Check of the last CAD data of the booster gabarit F4-440mm provided by the ISO CRS group (P Clayson, 2/03/2016)

Figure 10 — Envelope dimensions for booster seat, reduced width 440 mm — ISO/F4

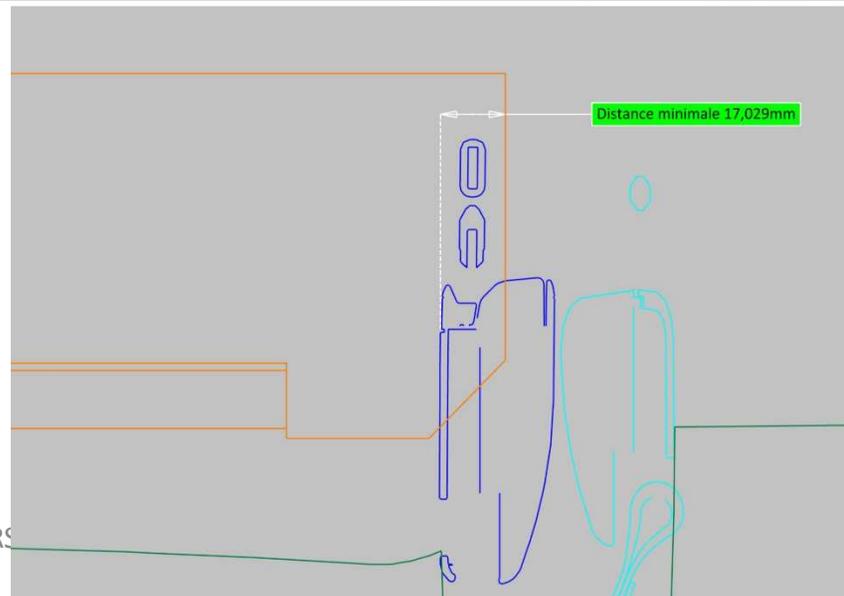
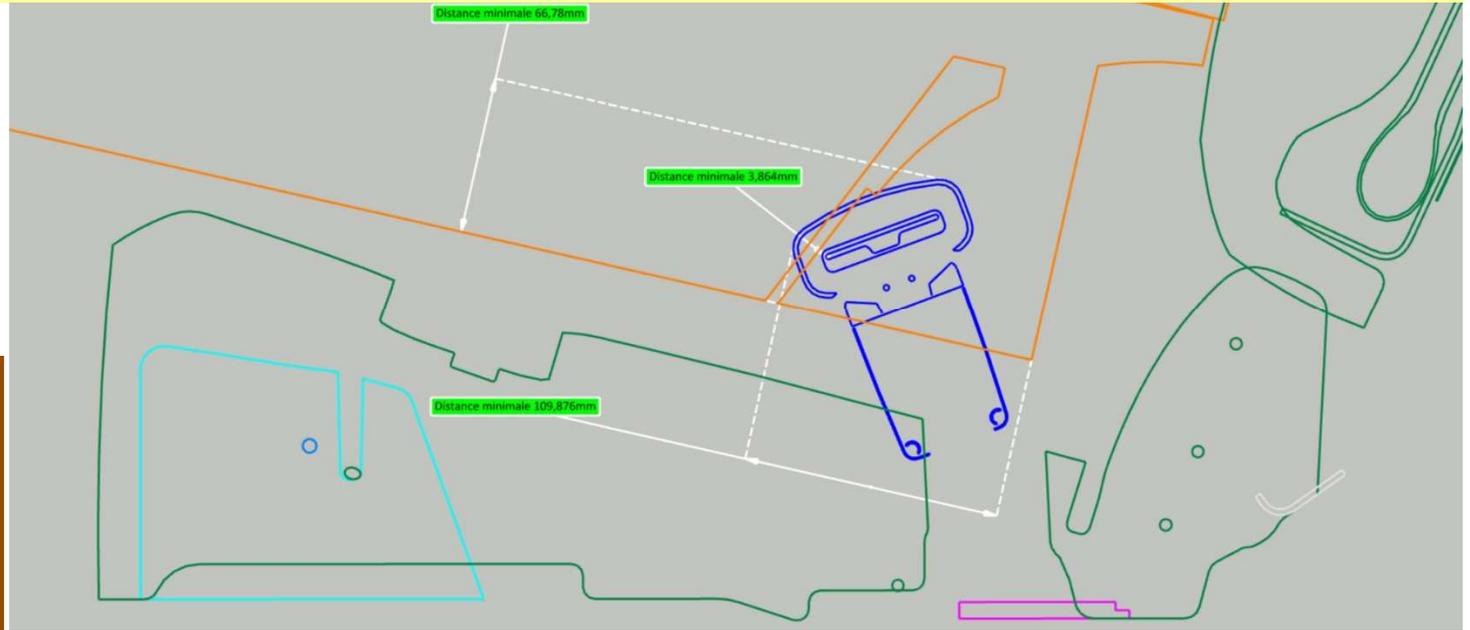
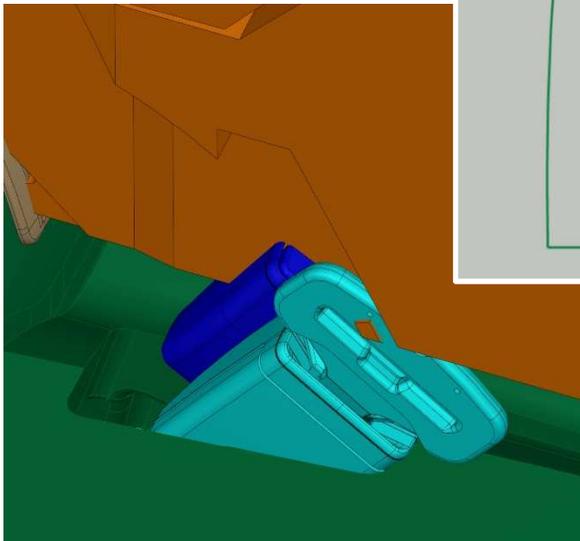
The buckle is OK with the R16 universal gabarit

If isofix links attached, interference of 17mm of the buklet with the gabarit width

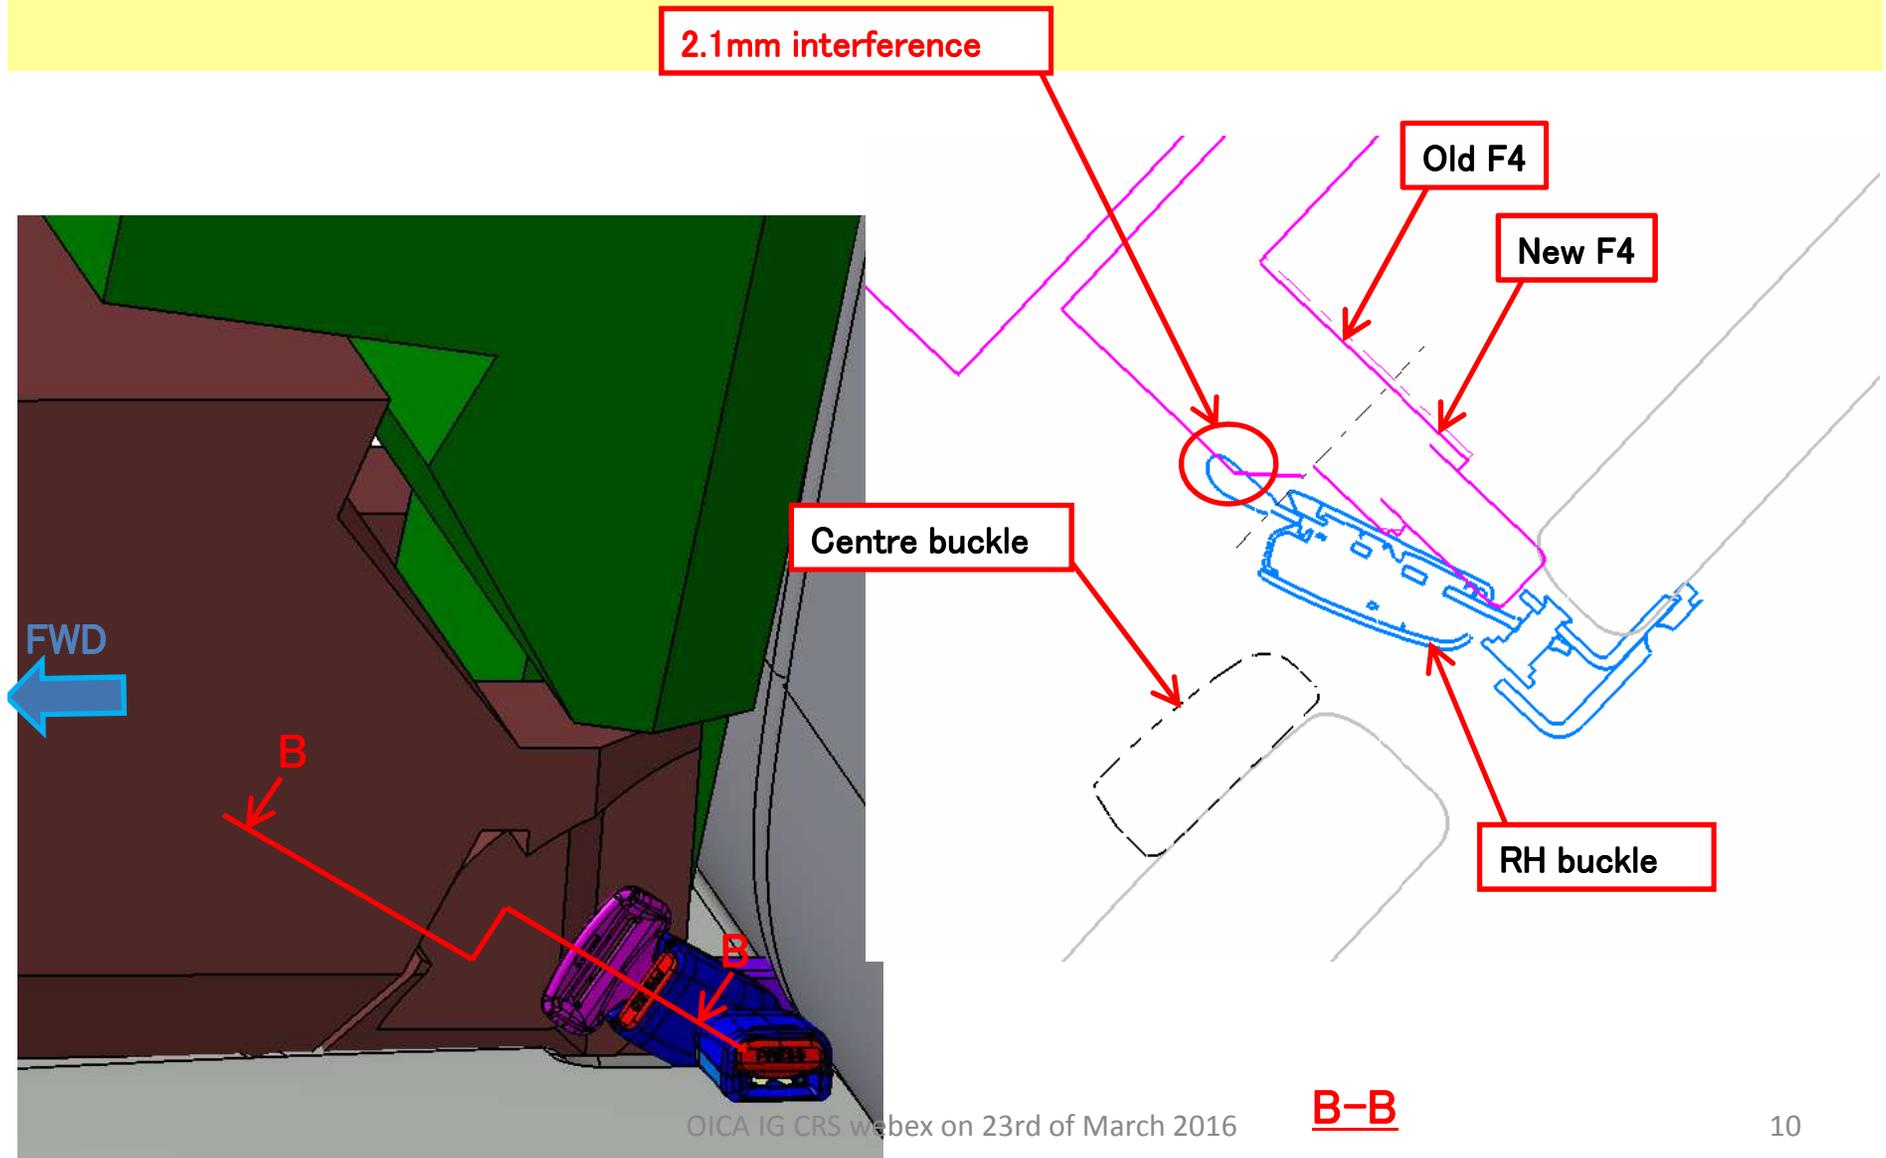
- if rigid vertical buckle, the gabarit will « sit » on the buckle => Nok
- Has the « twin buckle » for the centre position enough space if pushed by the blue buckle:
 - yes if flexible link, no if rigid link.

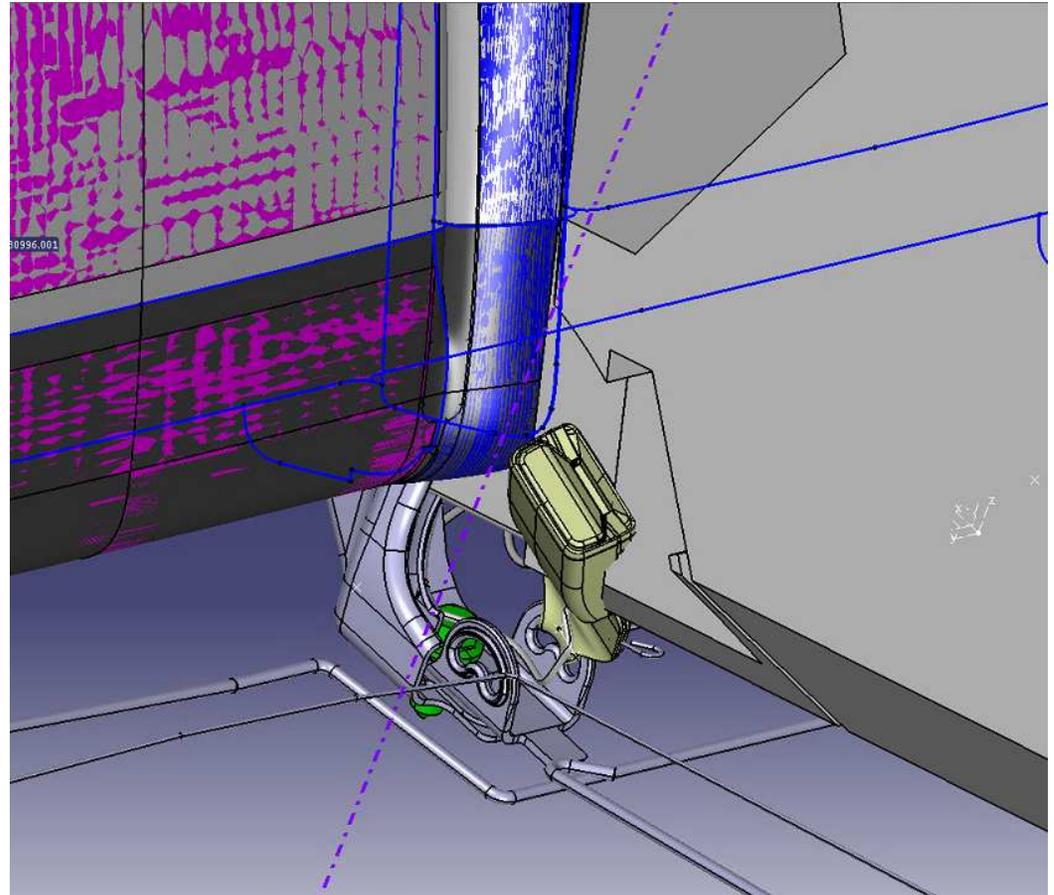
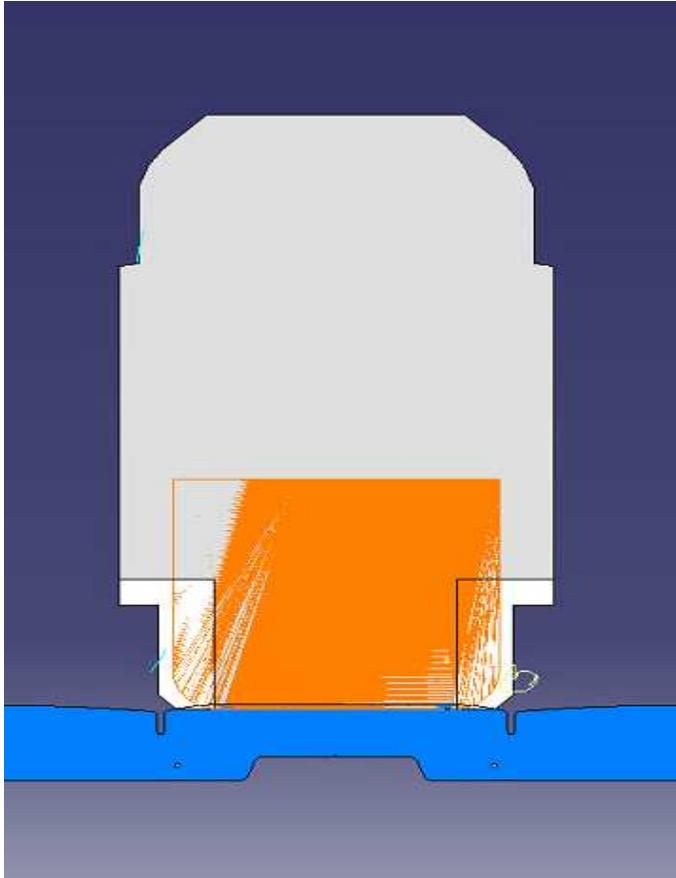
A 3rd case: Buckle area : Nok with F4 gabarit

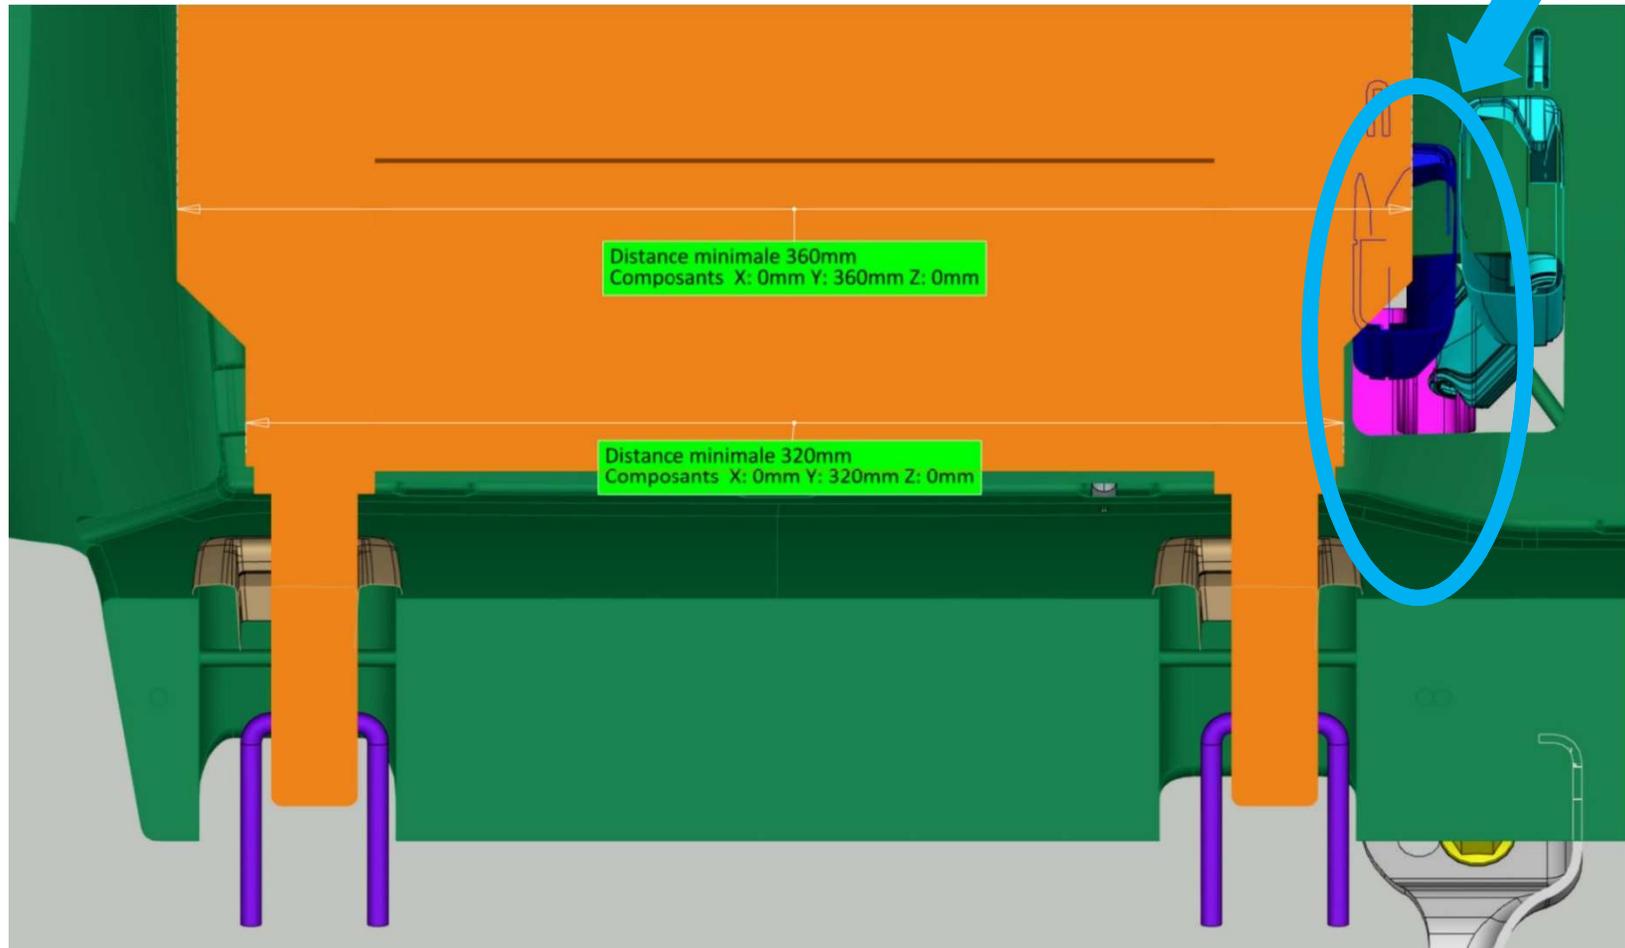
Interference of the booster gabarit with the buckle when Isofix links are attached

Isofix links = rigid

=> no tolerance possible in Y direction or rotation around X axis

=> risk to ban a good isize position if « booster seats only with isofix » because of head interference

keep the possibility to use i-size boosters with AND without isofix

2nd modification proposal

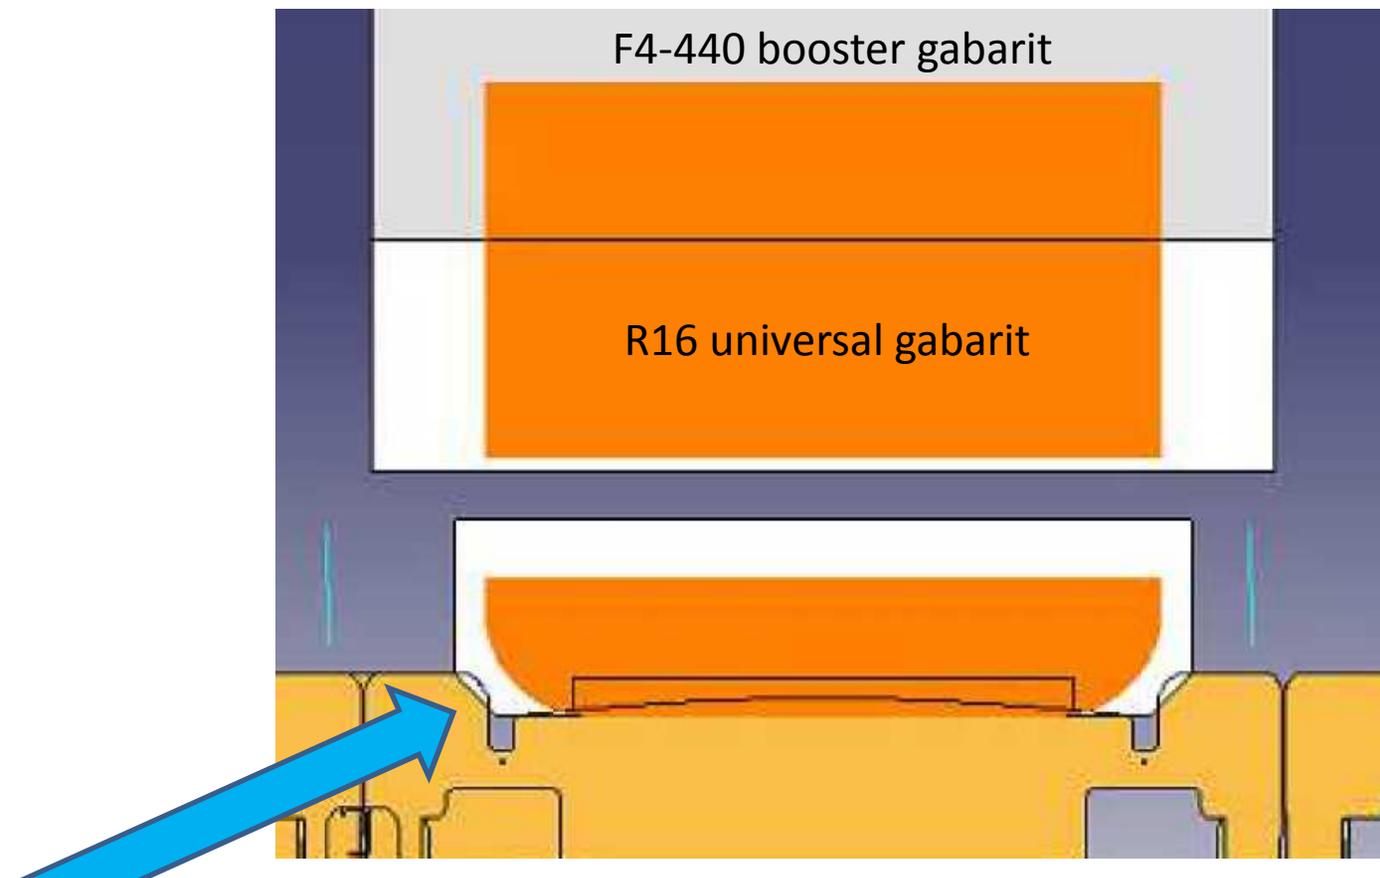
- Make the bottom more ergonomic, in order to better install the gabarit (copy the real CRSs bottoms)

R16 universal gabarit – copy the buckling area

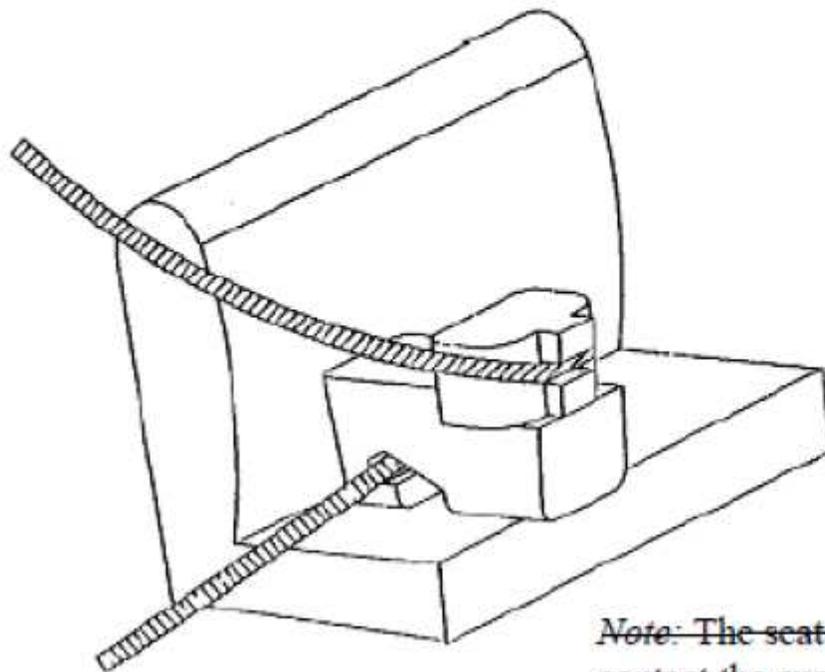
A Proposal to amend the buckling area: red dotted circle to allow ergonomic handling of the buck
